From: C-NLOPB Consolidated Review Comments – Dec 19, 2023 (Blue represents new information from Round 1 Review Comments and Responses)

Fisheries and Oceans Canada (DFO)

Review of Cenovus Responses to Round One Comments:

Figure 1 Environmental Effects Monitoring (EEM) program stations relative to particulate matter deposition boundaries (adapted from Figure 4.11 SINTEF). WWRP: West White Rose Platform. CDC: Central Drill Centre

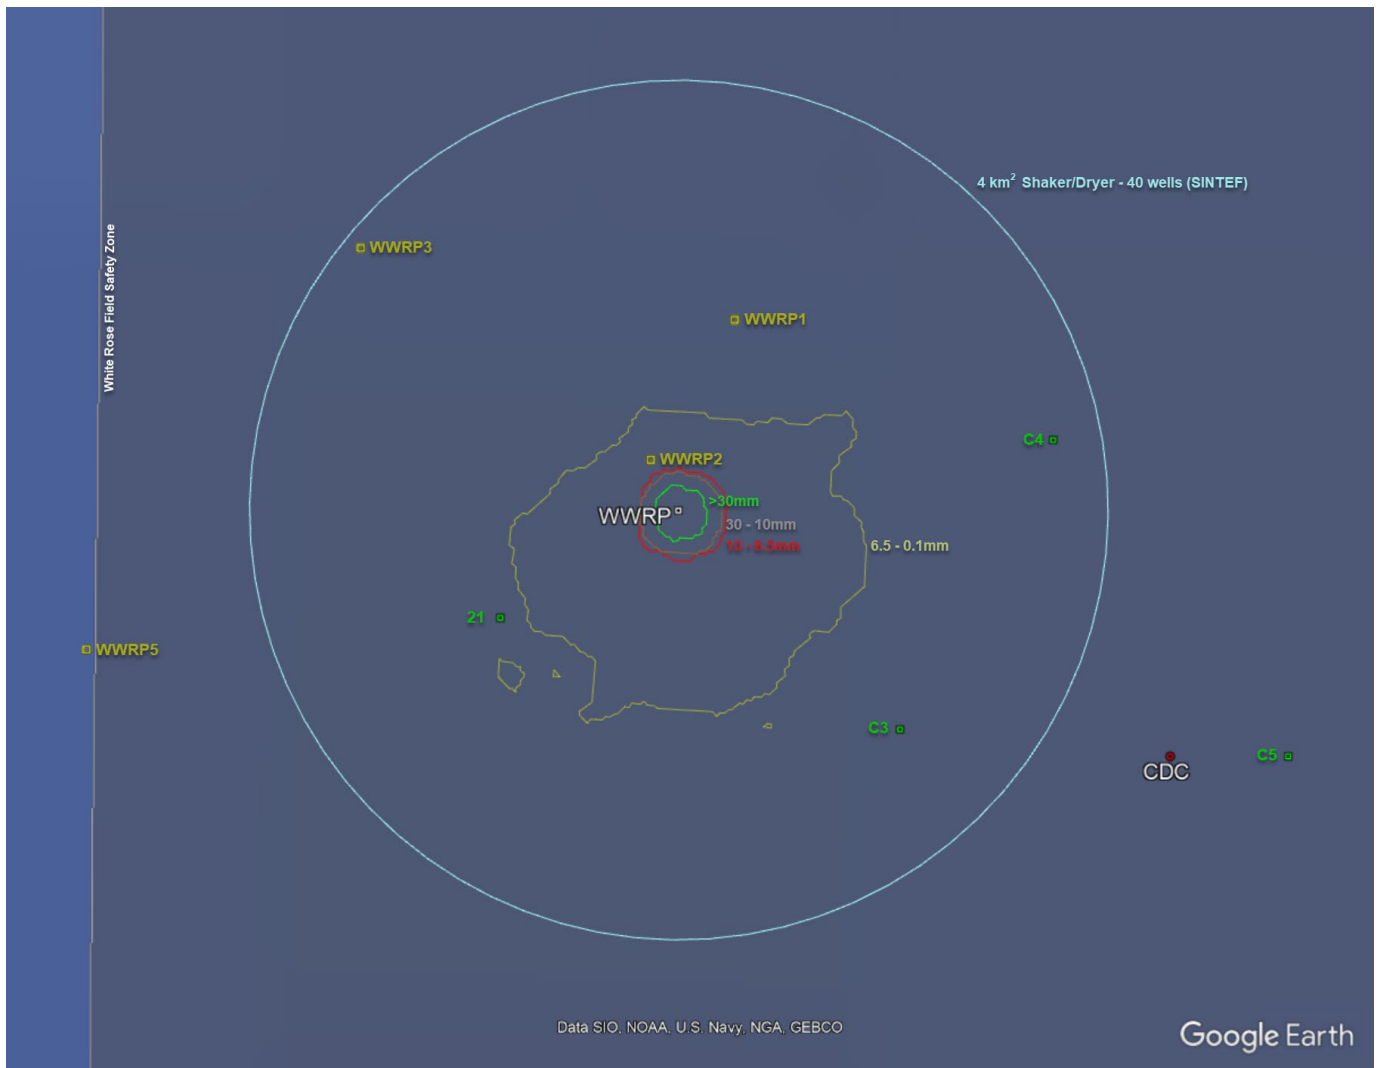
Is this description representative of the updated modelled dispersion area (0.1 mm boundary), as well as in the vicinity, for repeated drillings of 40 wells? If not, please provide additional habitat and species information to assist in DFO's assessment of impacts on fish and fish habitat.

SINTEF reported that the environmental risk for repeated drilling (up to 40) for the shaker/dryer discharge option could extend to 4km² (Figure 1). This represents a distance of 1.17km from platform, where the Wood model predicts 67.8% of the cuttings material to have settled to a mean thickness of 0.5mm (see Comment 1 above).

One EEM sediment station exists within the SINTEF 0.1mm boundary; WWRP2, whereas an additional five stations are within the 1.17km radius; WWRP1, WWRP3, C3, C4, and 21. To date, there have been no significant differences in the PSA analyses and benthic community composition amongst these stations, and these stations are representative of the habitat within and around the White Rose Field.

Figure 2 5% Oxygen Depletion Risk (Figures from SINTEF)

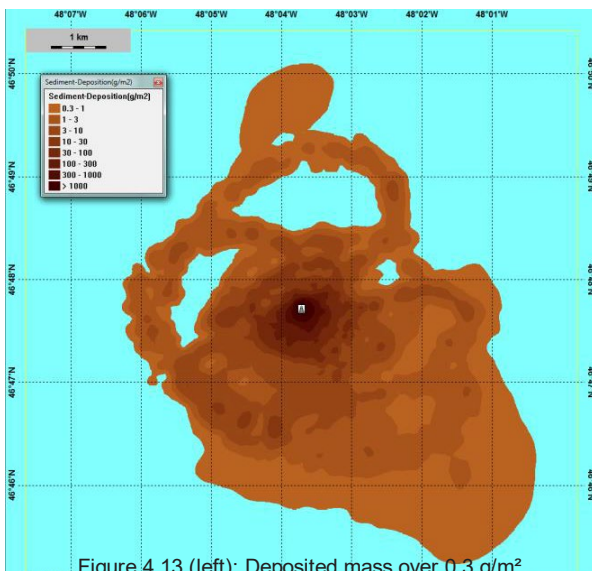
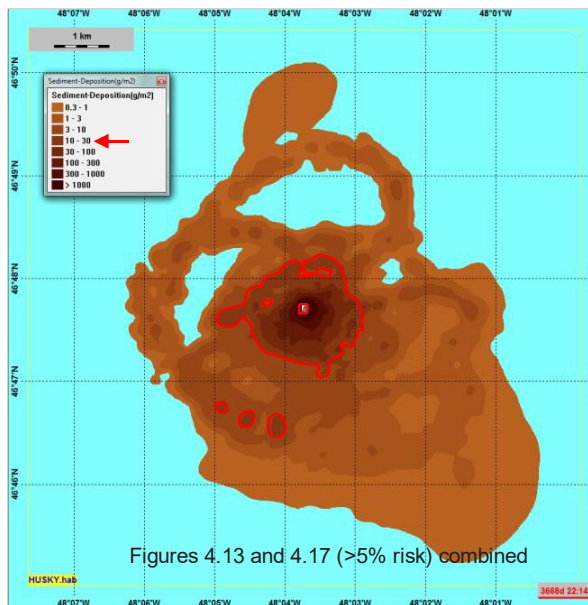
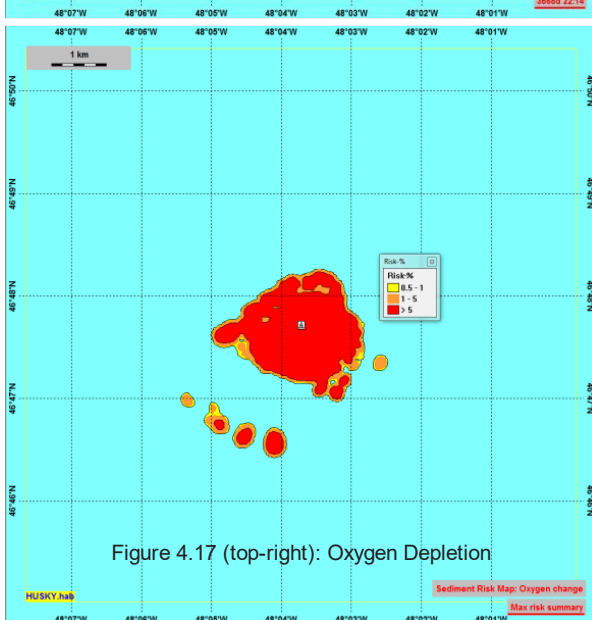
“ The outcome of the SINTEF modelling predicted that, for SBM cuttings treated with Shaker + Dryer +centrifuge, most (89.4 %) threat comes from oxygen depletion related to biodegradation of chemicals in areas with cuttings deposition $> 0.3 \text{ g/m}^2$ and that this effect may extend up to 1000 m from the origin for a 40 well program”.

Is this statement referring to Figure 6.3 in Section 6.3 (page 53), which illustrates deposition mass from repeated drillings (results from the model postprocessed for repeated drillings)? In Figure 6.3, deposition mass above 0.3 g/m^2 ($< 1 \text{ kg/m}^2$ from the Figure scale) extends 1 km from the center when drilling 1 well was modelled; deposition mass above 0.3 g/m^2 extends more than 2 kms from the center for 40 wells. Statement should be updated to indicate which section/figure(s) from the SINTEF modelling report is being referred to and accurately characterize results for a 40 well program.

Please include details on why 0.3 g/m^2 was selected as the threshold for oxygen depletion in the EA Amendment.

This statement is not referring to SINTEF Figure 6.3 in Section 6.3 (page 53), but rather Section 4.2 Sea Floor Results (page 38) in which Scenario 2 – 5.5% SOC is presented. The following Figure 2 superimposes SINTEF Figure 4.13 – Deposited Mass Over 0.3 g/m^2 with SINTEF Figure 4.17 (t-r) Maximum Risk for Oxygen Depletion. The $>5\%$ risk zone for oxygen depletion (total EIF contribution = 89.42%) extends to the perimeter of the 10 to 30 g/m^2 sediment deposition zone rather than the $>0.3 \text{ g/m}^2$ zone as was implied in the original submission. The 10 to 30 g/m^2 extends approximately 1,000 m from the platform.

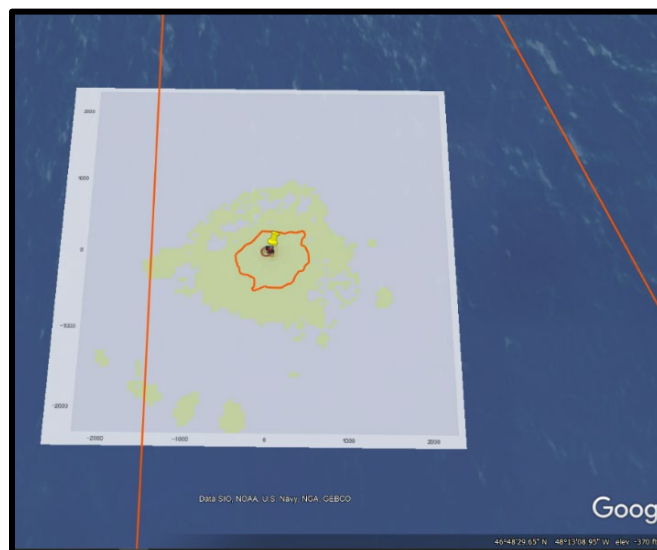
“The affected area is around the discharge location within a radius of approximately 1 km”

When referring to “affected area”, it should be clarified what drill cutting deposition thickness and number of wells were taken into account. As noted above, DFO is interested in the 1.5 and 6.5 mm thresholds for 40 wells. Revisions recommended.

The EA Amendment uses EEM data to determine environmental effects. The affected area, or zone of influence as referred to in an EA and EEM program, is not based on deposition thickness but rather, is based on the extent of effects to the benthic community. Results from the 2022 EEM indicate that there was evidence of project effects on benthic biomass near active drill centres and little to no evidence of effects on total abundance and richness. Decreases in biomass near active drill centre were related, in part, with decreases in the number of larger echinoderms.

Deposition Mass from 1 drilling operation. Straight red line is Safety Zone boundary. Red circle is the 6.5-0.1 mm thickness boundary (Figure 4.11) from Section 4.2.

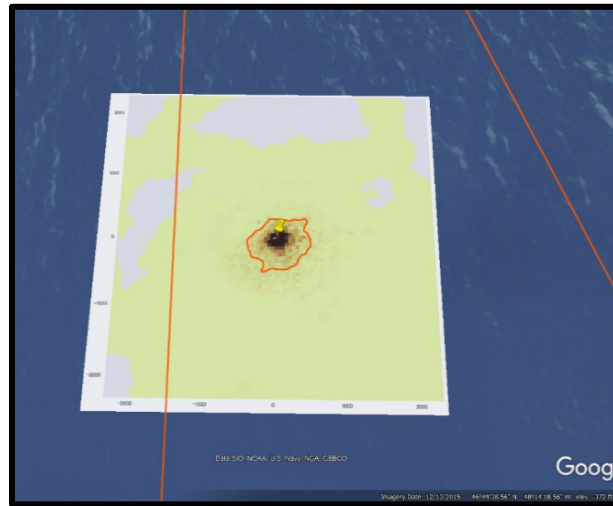
“The SINTEF model indicates that the extent of the drill cuttings at 0.1 mm depth do not extend beyond the White Rose Safety Zone (Figure 2.1)”

It is possible that drill cutting deposition at 0.1 mm may extend to the boundary or slightly beyond the safety zone after drilling 40 wells (see images below of sections from Figure 6.4, Section 6.2 – page 54 overlain on Google Earth). In the Wood report, considering the mean deposition thickness, 0.7mm extends out to 10-16km (Table 5-2, page 27). This would also be outside of the safety zone. The EA Amendment should be revised to reflect a 40 well program (with consideration of results from the Wood report).

As noted above, DFO is interested in the 1.5 and 6.5 mm thresholds for 40 wells. These thresholds do NOT extend beyond the White Rose Safety Zone and the 0.1 mm only extends to the boundary or slightly beyond the White Rose Safety Zone. The White Rose Field does not contain significant benthic habitat, and there are no corals identified in the area. As such, the PNET of 1.5 mm (pertaining to corals) and 6.5 mm (pertaining to significant benthic habitat) are not applicable to the White Rose Field.
